样品承认书

Project name项目名称:	P1018
Product name产品名称:	P1018_3IN1_ANT
Material number物料料号:	K5330000156LA
Material Description 物料描述:	FPC 0.12mm thick GPS/WIFI/BT antenna, black Shangyuan P1018_ three-in-one antenna FPC
Supplier Product Model 供应产品型号:	P1018_3IN1_ANT
TP FW mass production version TP FW量产版本	
Reminders提醒注意事项:	Each of the above information needs to be complete and accurate, and it needs to be consistent with the material information in the order BOM. 以上每项信息需要填写完整准确无误, 需要与下单BOM中的物料信息保持一致性。

PART NAME: 3IN1 ANT P1018

PART NO: SH253081B75-1S1

6 Environmental treatment.

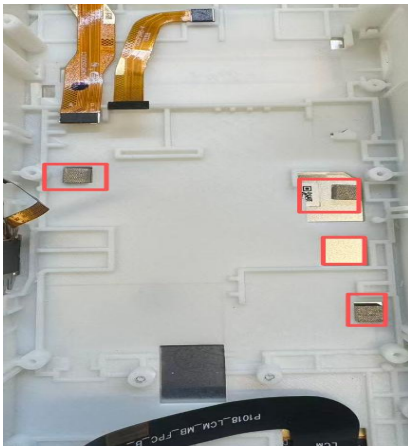
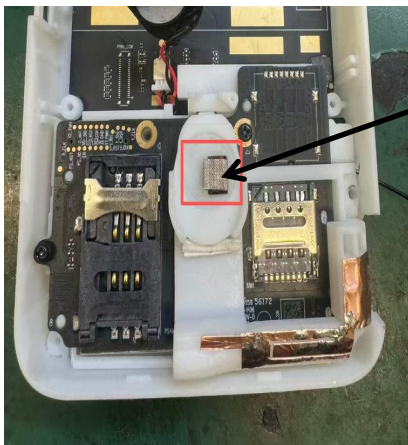
Increase the conductive sponge and motherboard grounding

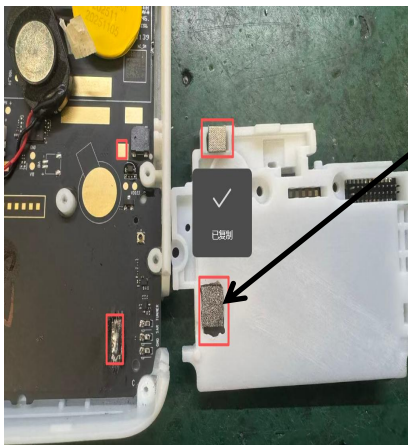
The horn is grounded to the motherboard through a conductive cloth

1. The bracket needs to be modified by digging holes in the mold, and the channel steel plate needs to be grounded to the copper leakage point of the motherboard through a conductive cloth

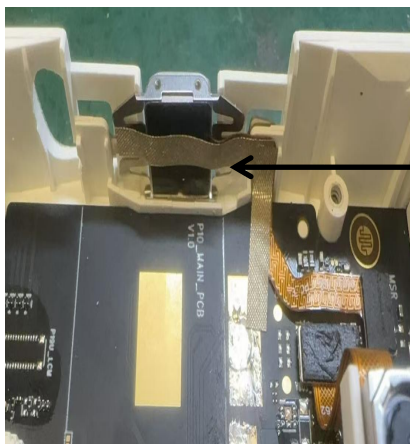
2. The main board next to the motor has a small copper leakage area, and it is recommended to increase the grounding area with the auxiliary board

The magnetic head is grounded through a conductive cloth
